**METROPOLITAN GOVERNMENT OF NASHVILLE AND DAVIDSON COUNTY**

**STAFF RECOMMENDATION**  
**1022 Acklen Avenue**  
**December 18, 2019**

**Application:** Violation/Show Cause; New Construction—Addition  
**District:** Waverly-Belmont Neighborhood Conservation Zoning Overlay  
**Council District:** 17  
**Base Zoning:** R8  
**Map and Parcel Number:** 1050933100  
**Applicant:** Brian Layton  
**Project Lead:** Jenny Warren, jenny.warren@nashville.gov

Figure 3: West elevation as revised, approved by Staff in November 2018 – note added dormers

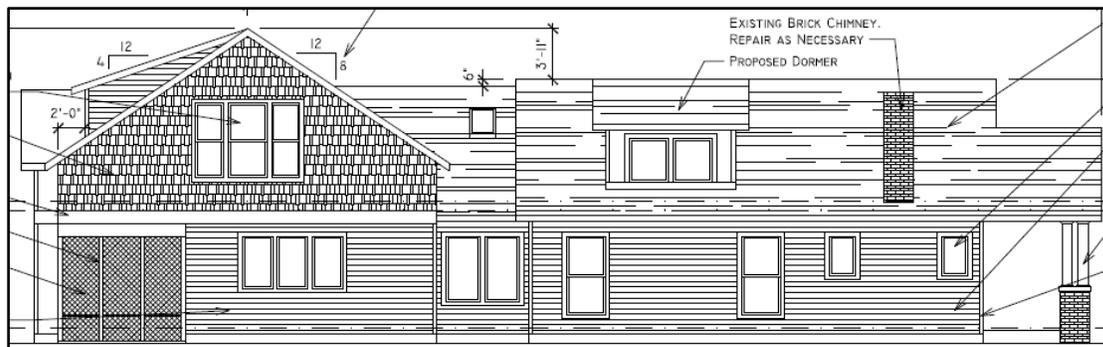
In October 2019, MHZC staff was conducting a routine permit inspection and noted that the small middle dormer had been constructed much larger than it was approved. The result is that the dormer extends over the roof valley between the side and front gabled

portions of the addition and that the middle dormer effectively blocks the face of the rear dormer. Dormers traditionally sit fully on a single roof plane – a dormer spanning a valley is not a condition that is seen historically or that staff recommends. Further, this work is on a highly visible side elevation, facing onto 11<sup>th</sup> Avenue South.

Roof form: As originally approved, the majority of the addition has a side-gabled roof form with a rear-facing shed dormer. It connects to the existing building with a short gabled ‘connector’ section six inches (6”) lower than the existing ridge. Ten foot (10’) wide shed dormers were approved for each side of the existing roof. The additional dormers, seen in Figure 3, were approved administratively by staff as a revision to the original permit. As proposed, those dormers meet the requirement of section IV.C.1.b of the guidelines and were “similar in design and scale to an existing dormer on another historic building that is similar in style and massing”. As constructed, the middle dormer is so wide that it spans the roof valley, a condition that is not present on this or similar historic houses. Staff finds the middle dormer does not meet section III.E for new construction-roof form and IV.C for additions. The dormer should be revised to reflect the dimensions and placement of the approved design.

**Recommendation:** Staff recommends that the middle dormer on the west elevation of the addition be reconstructed in a manner that matches the permit issued in July of 2018, as revised in August and November of 2018: HCP 2018038724 (Addition) within sixty days (60) of the date of this hearing.

**1 WEST ELEVATION**  
 SCALE: 1/8"=1'-0"

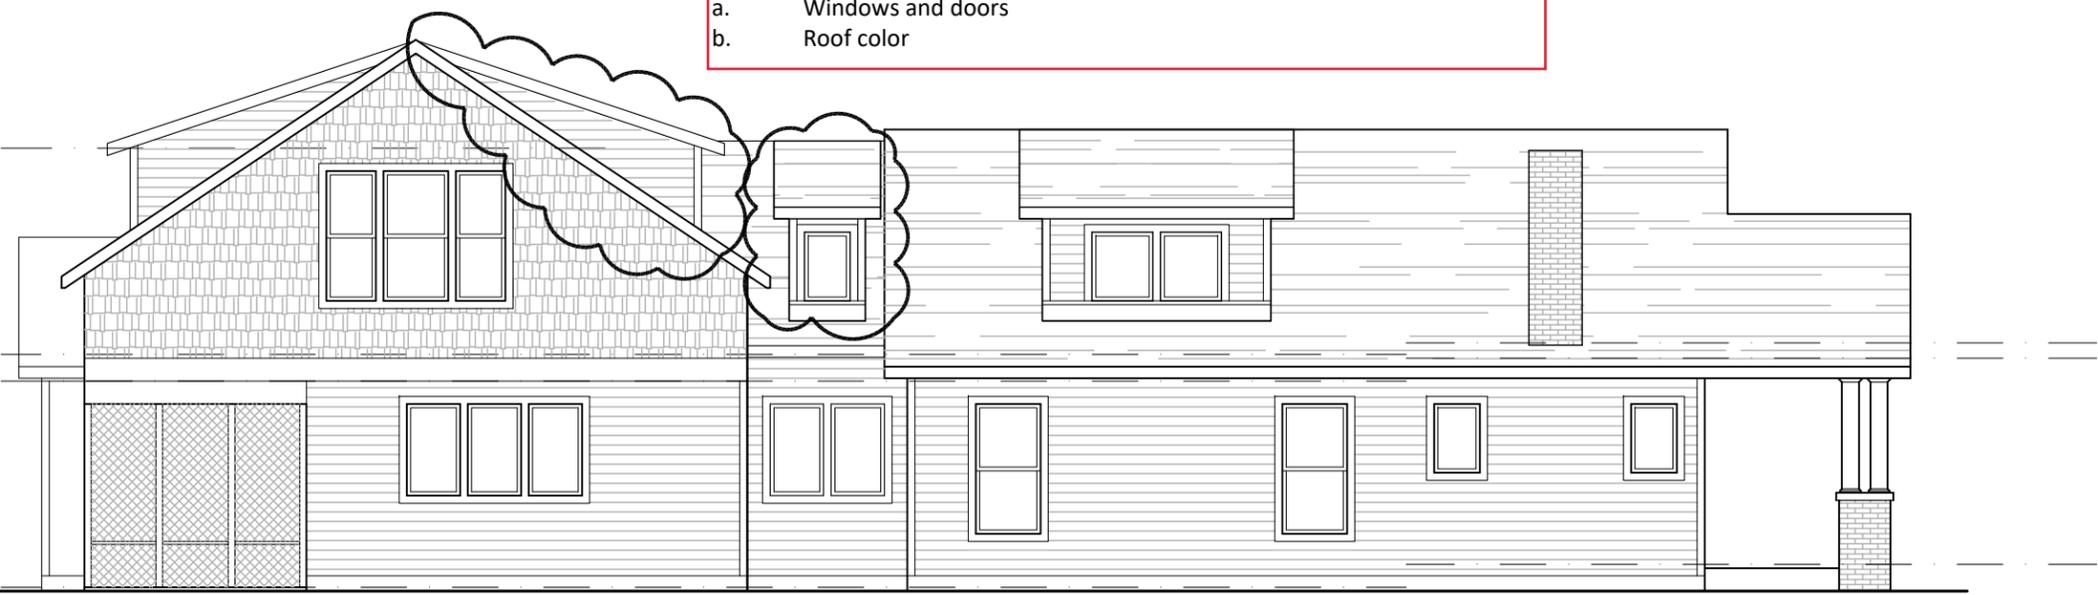
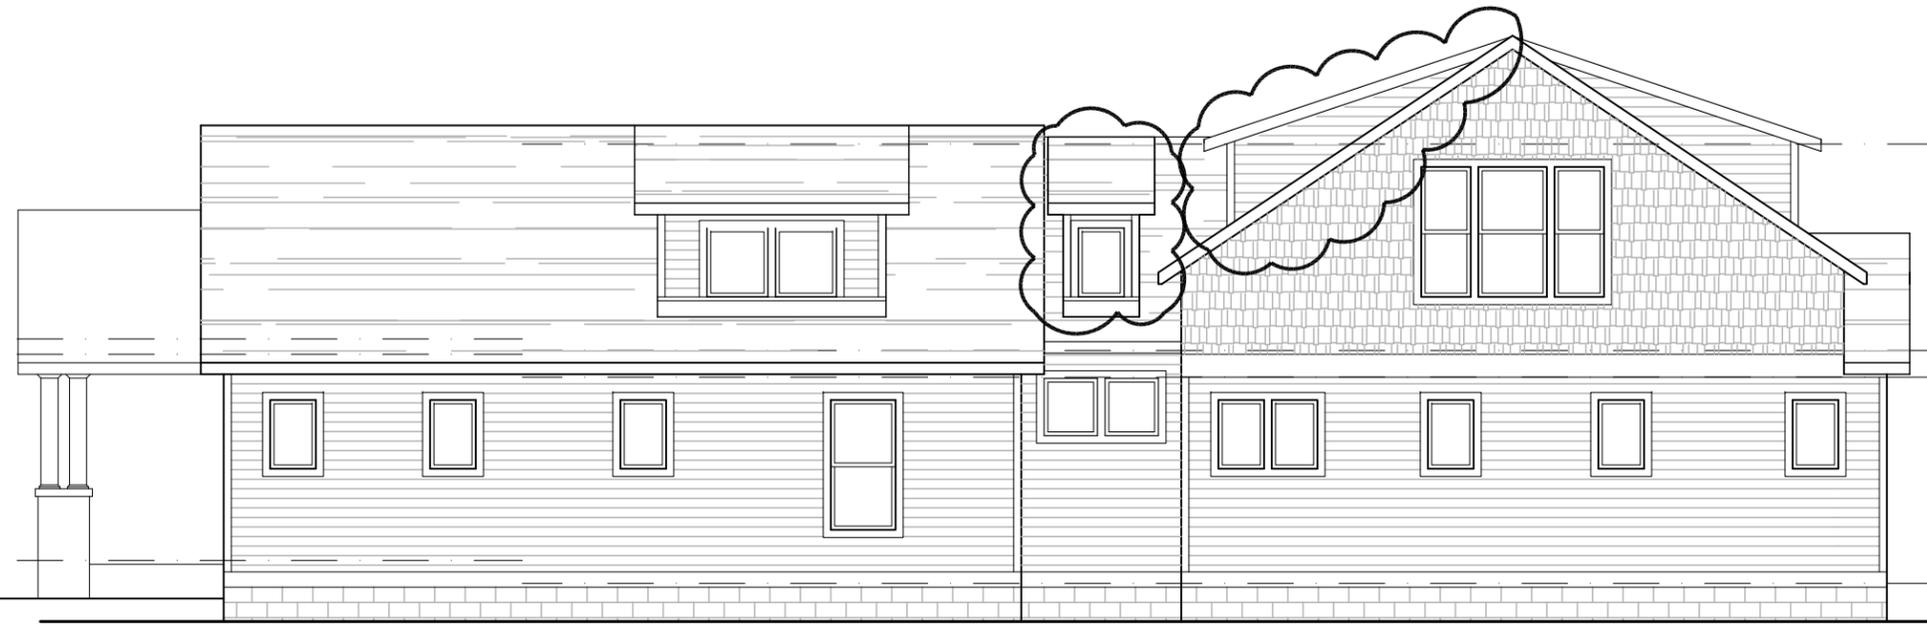
Staff finds that the addition, as currently constructed, does not meet the design guidelines for the Waverly-Belmont Neighborhood Conservation Zoning Overlay, for Section IV.C.1.b for Dormers and III.E. for Roof Shape.
